<input checked="" type="checkbox"/> ECO	<input type="checkbox"/> ECR	NO. 5007	EFF DATE OF CHG 21 Feb 97	REQUESTED BY ECR 1016	PREMIER	PAGE OF 2
REASON FOR CHANGE INCORRECT HDWR CALL OUT		DOCUMENTS AFFECTED B67-43001 B67-43001PL		SYSTEM BLADE FOLD KIT	MATERIAL DISPOSITION	
MARKED PRINTS ATTACHED YES <input type="checkbox"/>		NO <input type="checkbox"/>		SERIAL NO EFF	REWORK <input type="checkbox"/>	STORE <input type="checkbox"/> IN MFG.
					SCRAP <input type="checkbox"/>	
					USE AS IS <input checked="" type="checkbox"/>	<input checked="" type="checkbox"/>

DESCRIPTION

PREMIER
AVIATION, INC

B67-43001, SHEET 3

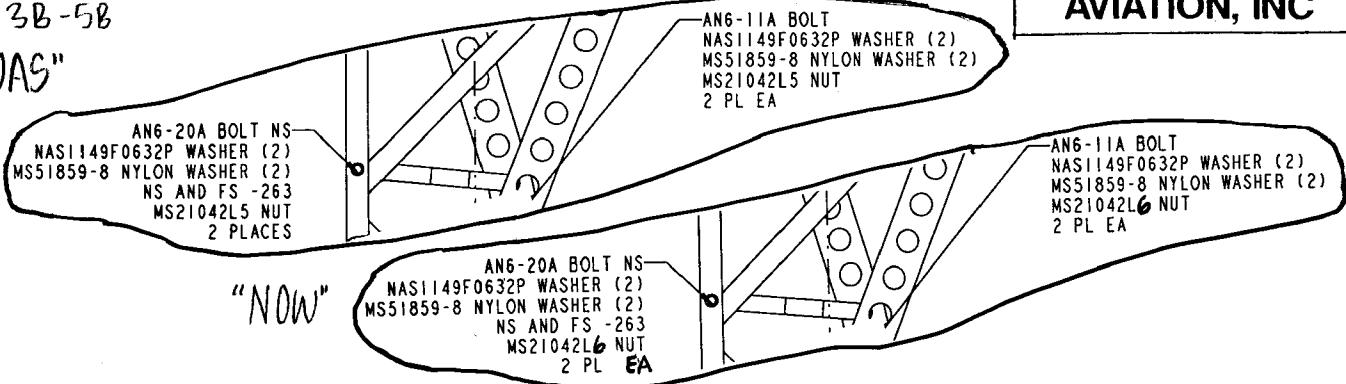
EN3B-5B "NAS"

"NOW"

AN6-20A BOLT (NS)
NAS1149F0632P WASHER (3)
MS51859-8 NYLON WASHER (2)
NS AND FS -263
MS21042LC5 NUT
2 PL EA

AN6-11A BOLT
NAS1149F0632P WASHER (2)
MS51859-8 NYLON WASHER (2)
MS21042L5 NUT
2 PL EA

AN6-20A BOLT (NS)
NAS1149F0632P WASHER (3)
MS51859-8 NYLON WASHER (2)
NS AND FS -263
MS21042L6 NUT
2 PL EA

AN6-11A BOLT
NAS1149F0632P WASHER (2)
MS51859-8 NYLON WASHER (2)
MS21042L6 NUT
2 PL EA

ZN 3B-5B

"WAS"

B67-43001, SHEET 4

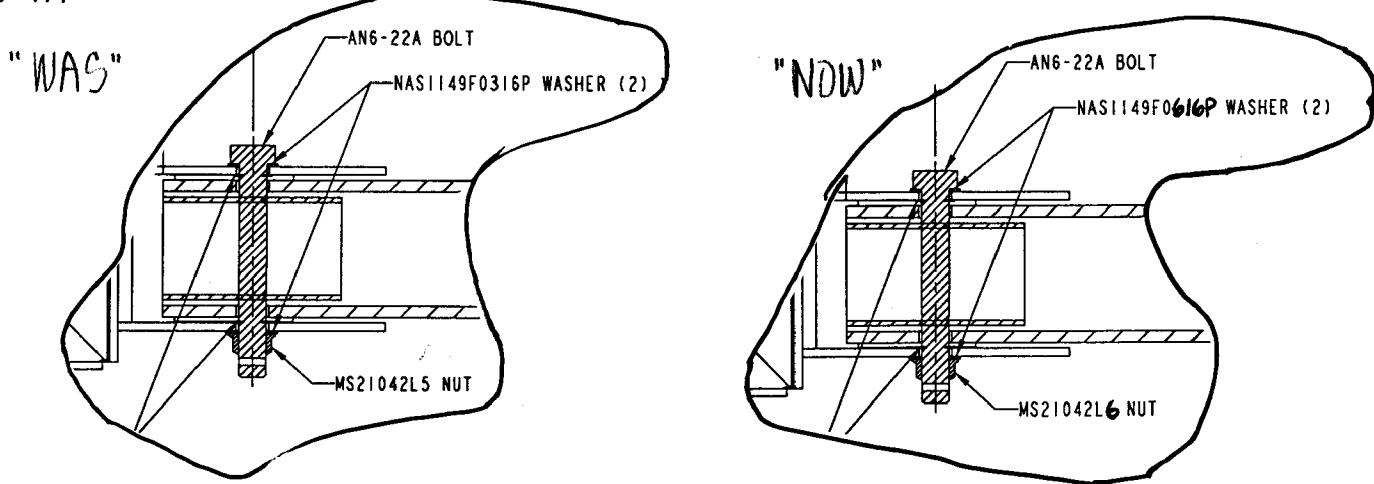
ZN 7A

CHANGE DETAIL "A" AS SHOWN, ZN 7A:
